Potential Mixed Use Development New Veterinary Surgery

At Riverside Works, Woodhead Road, Honley HD9 6PW
On Behalf of Donaldson's Vets Ltd

Supporting Statement:
Response to LA Planning Consultation in relation to Design Matters

Document Ref: C1098 451	Revision Number: 0		
	Initial Issue		
Author:	Kevin Dawson		
Position:	Director		
Date of Issue:	15 April 2025		
Notes:

Local Authority Comment 1

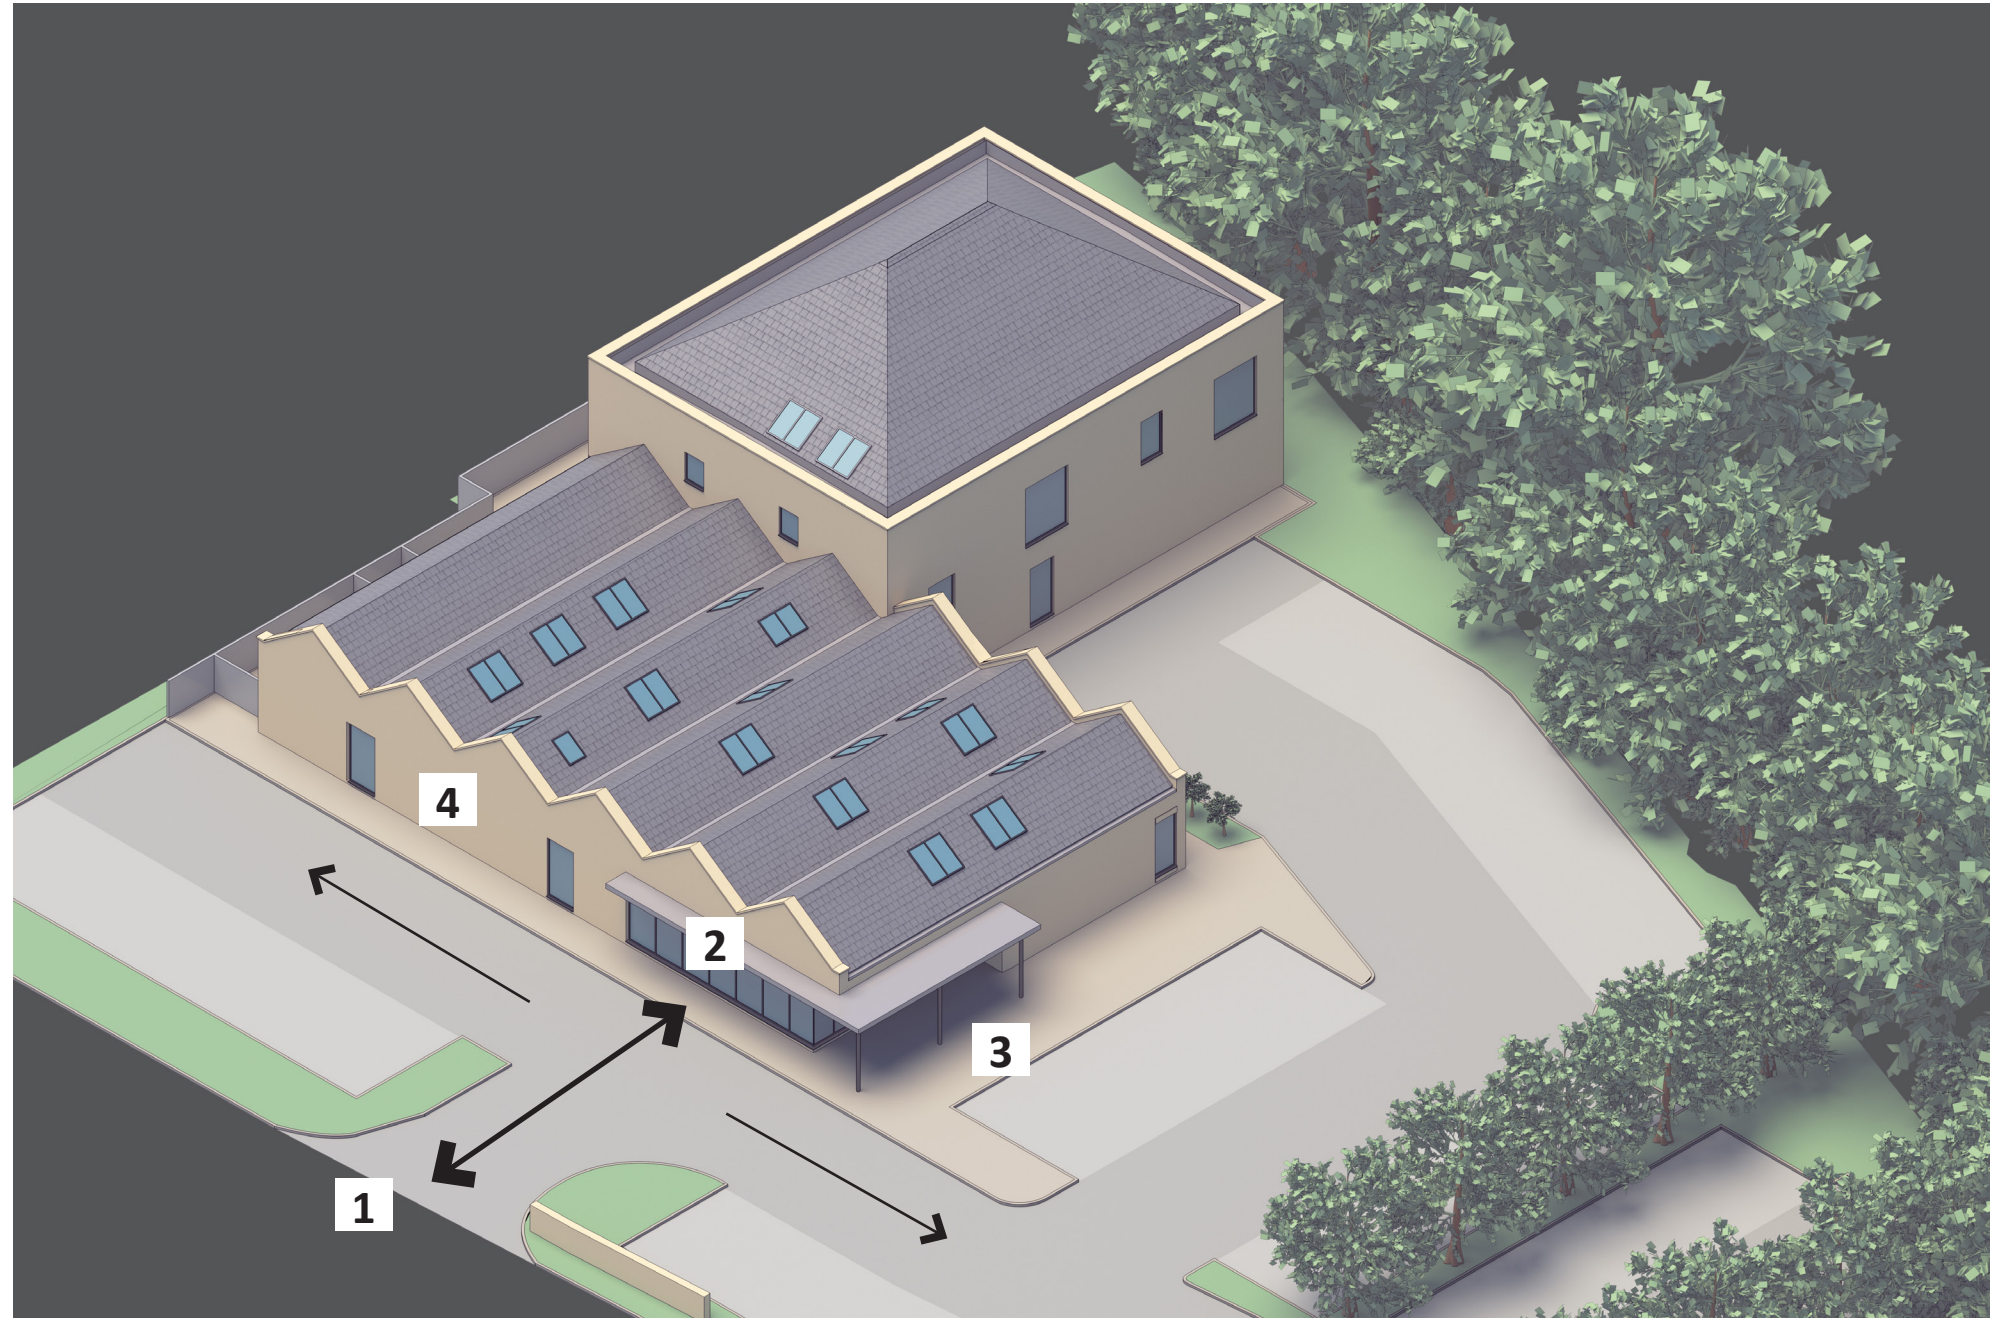
The front elevation of the single storey section is the 'primary' frontage of the building and is considered to be lacking in aesthetic qualities.

Ultimately, this elevation needs to be an attractive feature in its own right. Consideration should be given to enhancing the design of this elevation, in the form of fenestration, to achieve an attractive and active frontage to the building.

- 1 The location of the pedestrian / vehicular access to the site has been re-located following the completion of a speed survey and confirmation that the visibility splay works for this location by VIA Solutions.

The new location for the site access means that visitors immediately feel a connection to the activity inside through a visual connection (the new access route is directly opposite the extended glazed wall / corner.

- 2 The elevation facing onto Woodhead Road and Waiting Area plan have been redesigned to create a more active frontage than the original submission by increasing the amount of glazing and creating a glazed corner at the southern most point of the building.
- 3 The entrance (facing south) is positioned as the returning section of the glazed corner (item 2) within a subtractive run of panelling linked to a projecting canopy which reaches into the car park and provides shelter on the approach.
- 4 There is a need for the elevation to be more solid opposite the car parking spaces to the north of the site entrance due to the privacy which is required in a veterinary consulting room. Glazed panels are to be formed in strategic locations offering visual connection from circulation spaces to the inside and outside.

Somerset Road Section

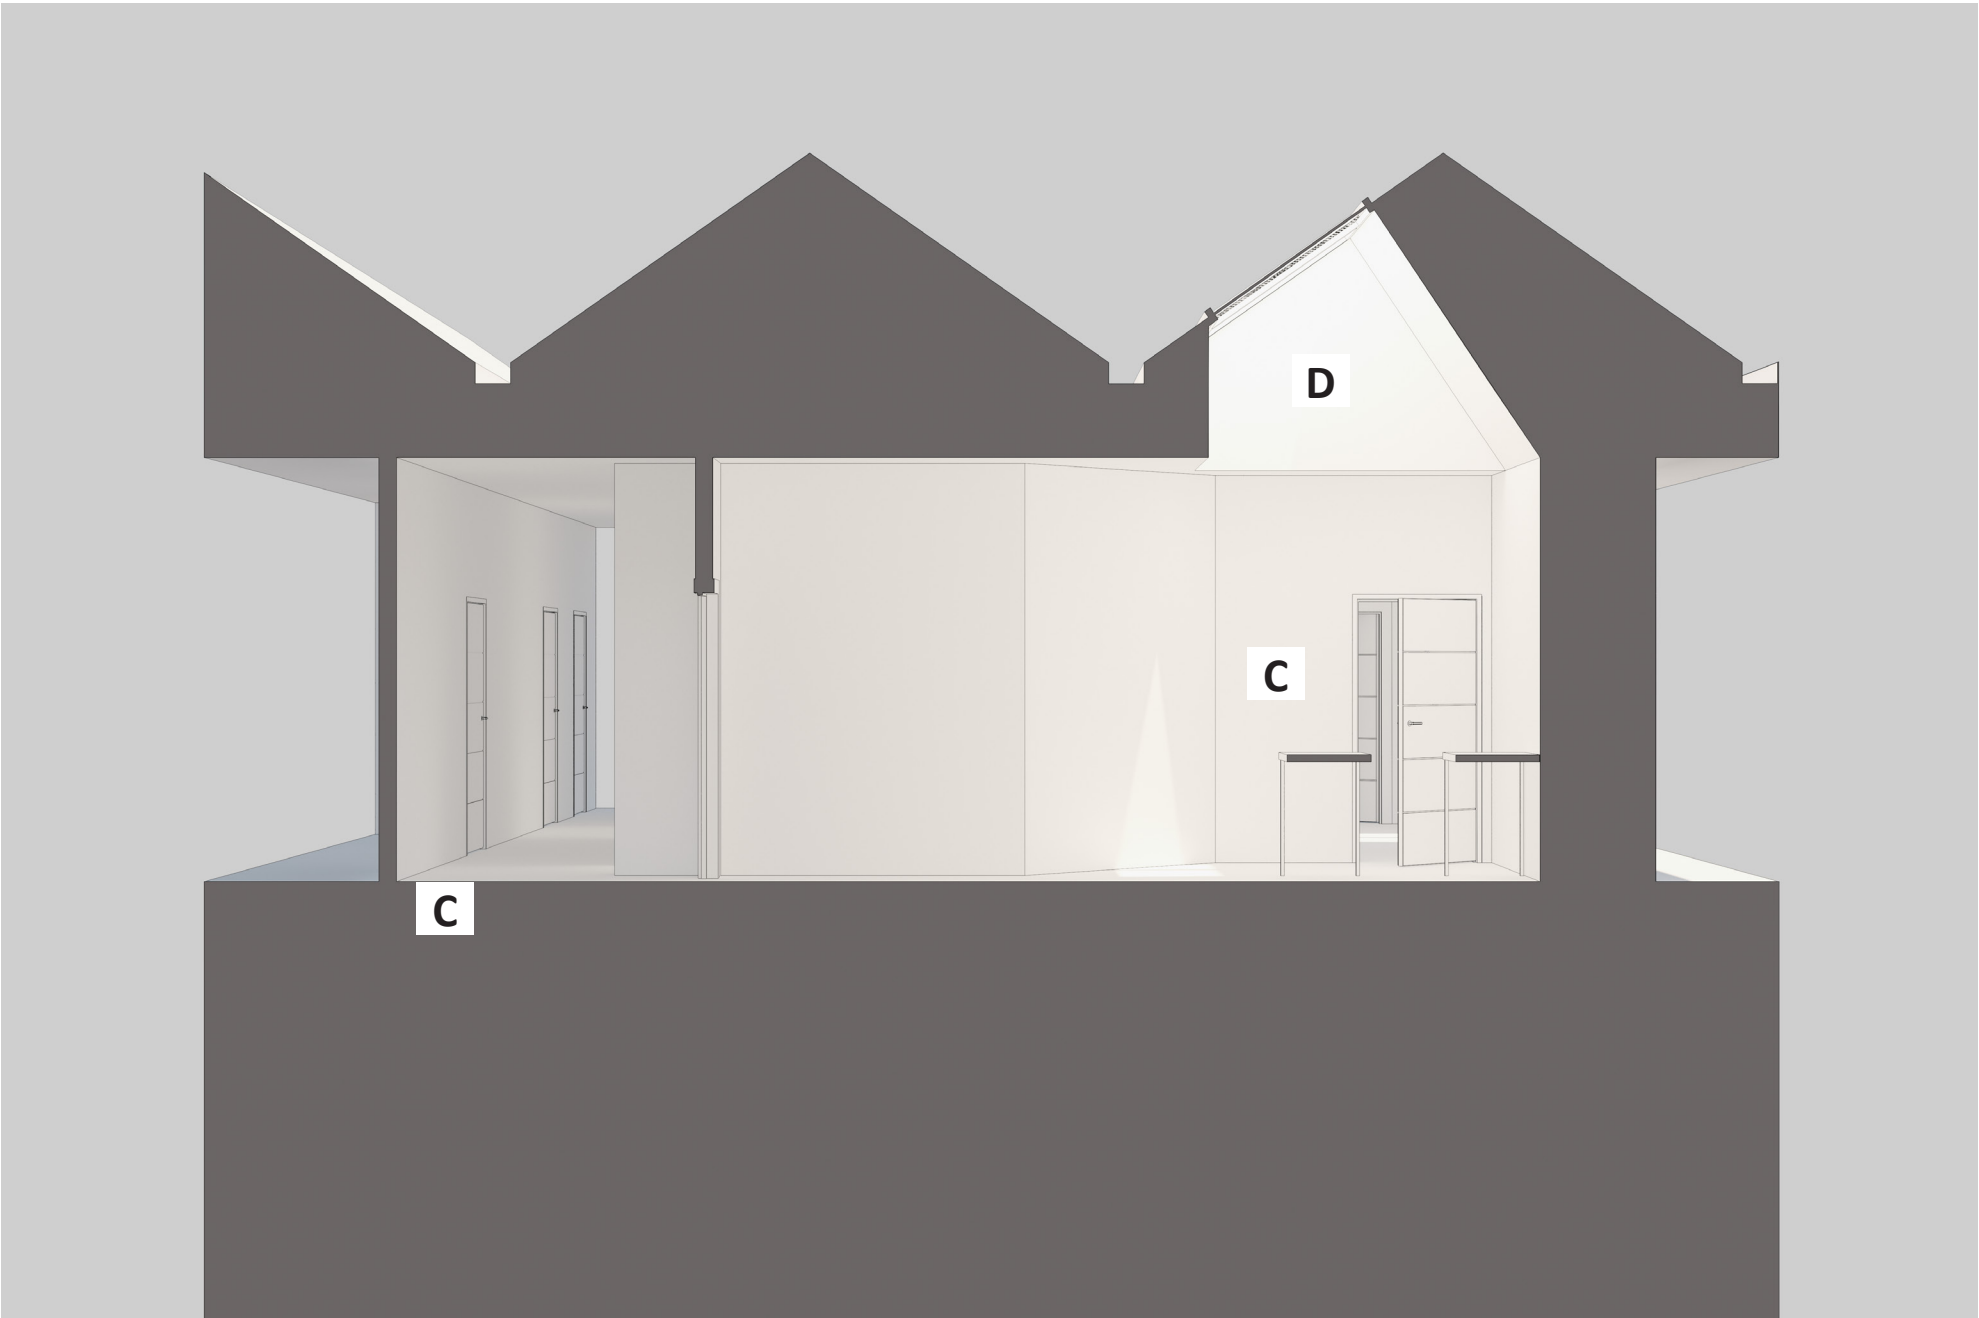
The design inspirations are not considered to work appropriately at this site.

The building, as currently proposed, has the mass, scale, roofing form and overall silhouette of a traditional mill, but with modern materials and fenestration that results in a design which does not reflect the best design features of either traditional or modern design.

The Consulting Rooms suffer because they are positioned in the depth of the plan with no natural light.

Floor / Space Above, No Natural Light, Reliance on Artificial Lighting
